Product: A/V Receivers

Hardware Technical Bulletin: T163-H2004-01

Date: June 15, 2004

Subject: Flat Ribbon Cables

Figure 1

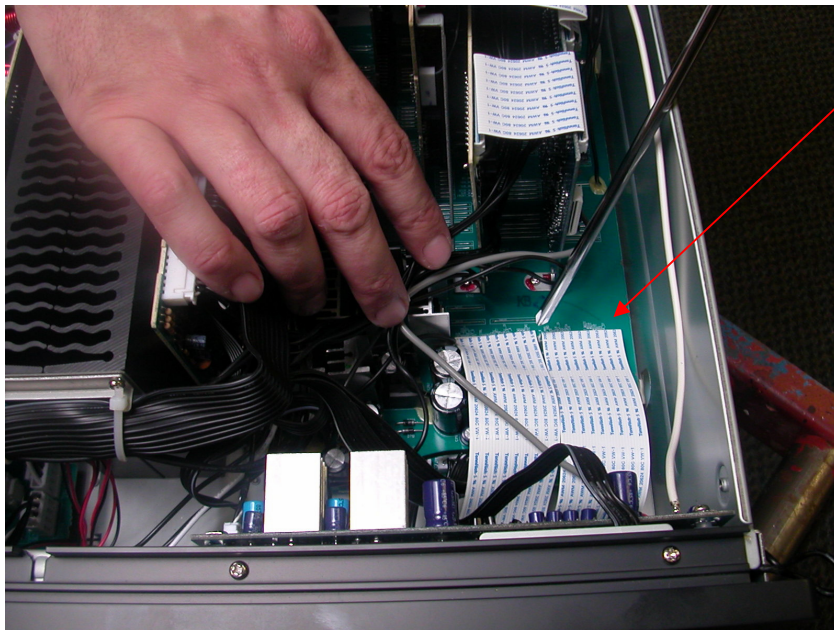
Locate and remove the ribbon cables, front panel cables shown.

SOLUTION: *Clean all ribbon connectors using an eraser or preferably a non alcohol based cleaner which will leave no residue. See figures 1, 2 and 3.*

Figure 2

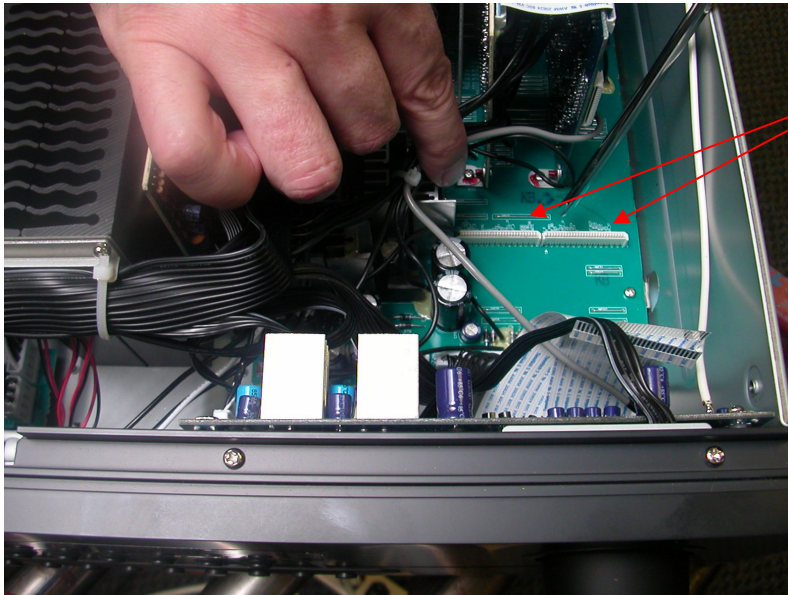
Ribbon cables are easily unplugged from these connectors.

Figure 3

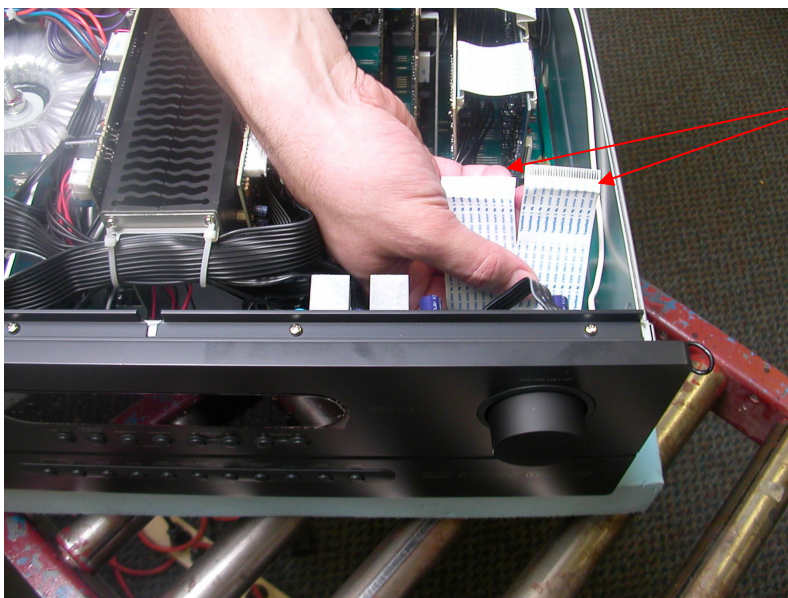
Clean the ends of the ribbon cables with eraser or non alcohol based cleaners.
